## Product Advisory

Issue Date: June 23, 2020

**Advisory Type:**  
Regulation Update

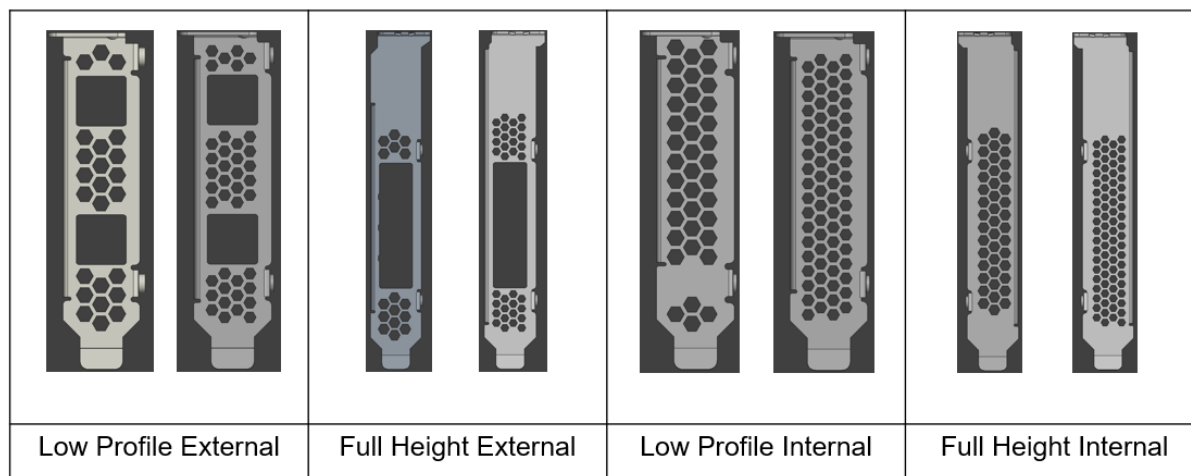
IEC 62368 is a system level requirement, and the adapters need to align with IEC 62368 requirements to enable overall system compliance. To meet the IEC 62368 system requirements, adapter bracket holes are being modified to be 3 mm or less in diameter.

The following pictures show examples of current brackets (left) and the updated brackets (right) that are IEC 62368 compliant. These are typical examples of each bracket for illustrative purposes, and the actual brackets on a given card may vary slightly in design or hole placement. In each column, the bracket on the left is the older design and bracket on the right is the updated design with holes less than 3 mm.

The BOMs for each part number will be updated to remove the current brackets and add the new brackets. This will result in a minor revision change to the part number.
